# Product Change Notification

## 108536 - 00

**Change Notification #:** 108536 - 00  
**Change Title:** Intel® Carrier Grade Server TIGH2U, PCN 108536-00, Product Design, Move wall of air duct away from PCI keep-out zone  
**Date of Publication:** June 09, 2008

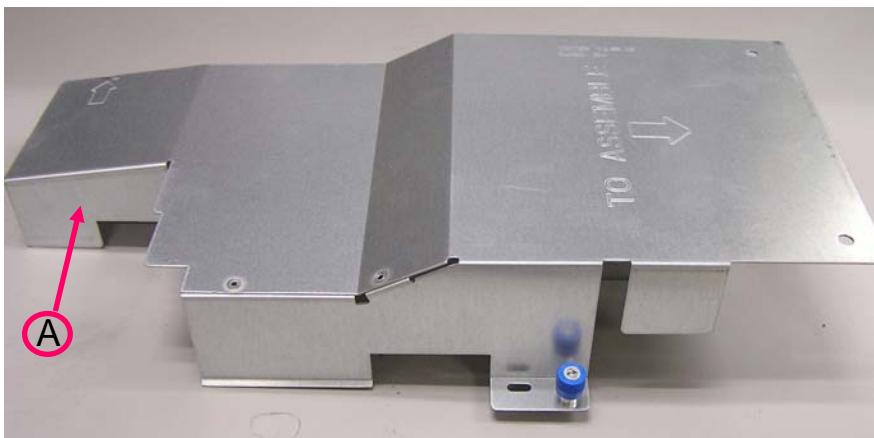
Intel moved the wall of the CPU/DIMM air duct 1.75mm toward DIMM slot#1 to resolve the interference issue with low-profile PCI boards. The wall location was changed by modifying the "break" in the sheet metal. See label "A" in the photo that follows.
